SUBDIVISION,

ZONING AMENDMENT STAFF REPORT Date: March 15, 2007

SUBDIVISION NAME Mobile Rosin Oil Subdivision

LOCATION 2469 Bragdon Avenue

SITE PLAN

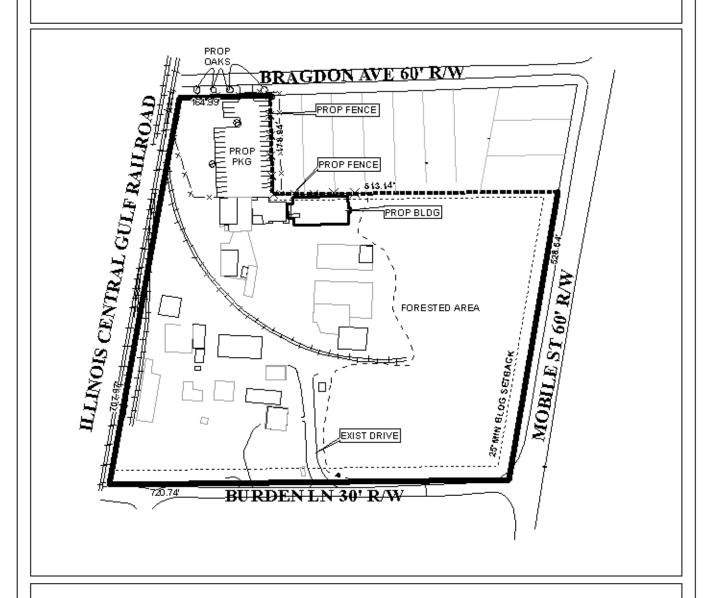
The applicant is requesting PUD approval for multiple buildings on a single building site. The site plan shows additional parking, which would exceed the parking requirements for the existing business and the proposed addition.

While no landscaping percentages are illustrated on the site plan, more than a third of the site is illustrated as forested area. As illustrated on the site plan, frontage trees required along Bragdon Avenue are placed in the right-of-way. However, the Ordinance requires the trees be placed on private property, within the 25-feet minimum building line. Additionally, full compliance with the landscaping and tree requirements of the Ordinance for the entire lot would be required.

Since this site adjoins and faces residential zoned property, buffers per Section 64-4. D of the Zoning Ordinance would be required.

Planned Unit Development The request is recommended for Approval, subject to the following conditions: 1) the completion of the rezoning process prior to the issuance of any permits; 2) the dedication of sufficient right-of-way to provide 50-feet from the centerline of Mobile Street; 3) the dedication of sufficient right-of-way to provide 25-feet from the centerline of Burden Lane; 4) the dedication of appropriate radii at the intersection of Mobile Street and Burden Lane, to be determined by City Engineering and Traffic Engineering; 5) the placement of a note on the Final Plat stating large truck traffic is denied access to Bragdon Avenue; 6) the depiction of the 25-foot building setback, measured from property lines after dedication; and 7) the placement of a note on the final plat stating that, where the site is adjacent to, or faces residentially developed property, a buffer must be provided, per Section 64-4.D of the Zoning Ordinance.

SUBDIVISION AND ZONING DETAIL

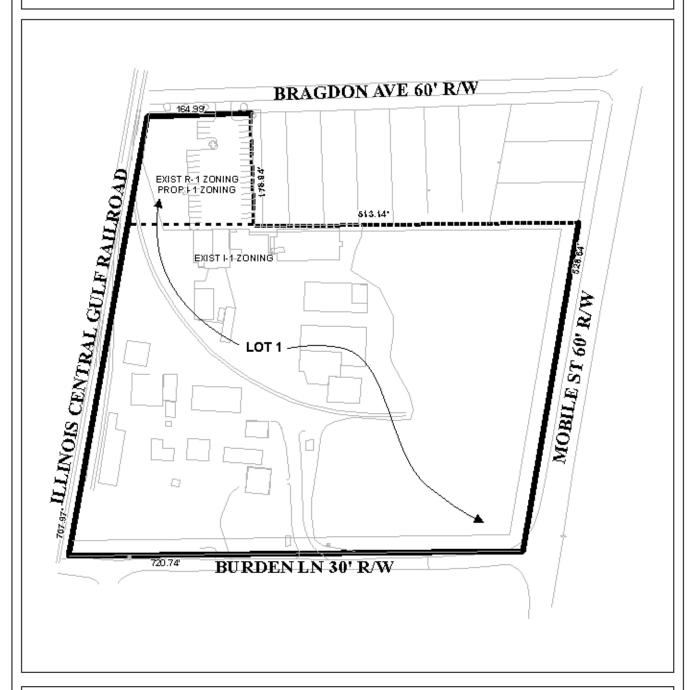
The proposed subdivision fronts Mobile Street, Bragdon Avenue and Burden Lane. Mobile Street, a major street as illustrated on the Major Street Component of the Comprehensive Plan, is illustrated as having 60-feet of right-of-way, requires 100-feet of right-of-way. Bragdon Avenue and Burden Lane, both minor streets and are illustrated as having 60-feet and 30-feet of right-of-way respectively. Minor Streets require a minimum of 50-feet of right-of-way; therefore, the dedication of right-of-way sufficient to provide 50-feet as measured from the centerline of Mobile Street and the dedication of sufficient right-of-way to provide 25-feet from the centerline of Burden Lane should be required. In addition, the dedication of appropriate radius at intersection of Mobile Street and Burden Lane would also be required. The required 25-foot setbacks are not shown on the preliminary plat would be required on the Final Plat.

Regarding the proposed rezoning, the developed portion of the property is currently split zoned R-1, Single-Family Residential and I-1, Light Industry, and the applicant proposes construction of another building and parking. Rezoning the entire site to I-1 is necessary for the proposed subdivision, would provide greater consistency for this area, and would be appropriate for the existing use.

RECOMMENDATION Subdivision Based on the preceding, the plat meets the minimum requirements of the Subdivision Regulations, and is recommended for Tentative Approval, subject to the following conditions: 1) the completion of the rezoning process prior to the issuance of any permits; 2) the dedication of sufficient right-of-way to provide 50-feet from the centerline of Mobile Street; 3) the dedication of sufficient right-of-way to provide 25-feet from the centerline of Burden Lane; 4) the dedication of appropriate radii at the intersection of Mobile Street and Burden Lane, to be determined by City Engineering and

Traffic Engineering; 5) the placement of a note on the Final Plat stating large truck traffic is denied access to Bragdon Avenue; 6) the depiction of the 25-foot building setback, measured from property lines after dedication; and 7) the placement of a note on the final plat stating that where the site is adjacent to, or faces residentially developed property, a buffer must be provided, per Section 64-4.D of the Zoning Ordinance.
